TECHNICAL BULLETIN

MODEL/DERIVATIVE:
MINI

Bull. N°: **0004**
CDS. ref: **R5898bu**
Issue: **1**
Date: **25.05.94**

PROBLEM:
ENGINE SHUNT - WEAK STEADY BAR BUSHES

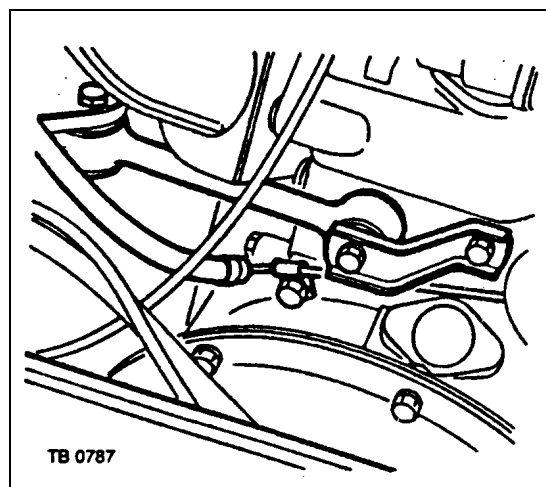
Engine shunt / kick, at light throttle. This condition may appear from approximately 6000 miles (9600 Kilometres) onwards.

CAUSE:
Upper engine steady bar bushes providing insufficient damping

ACTION:
Replace existing bushes with heavy duty bushes.

PARTS INFORMATION:
KKF100390 - Bush Engine Steady (heavy duty) - 4 off
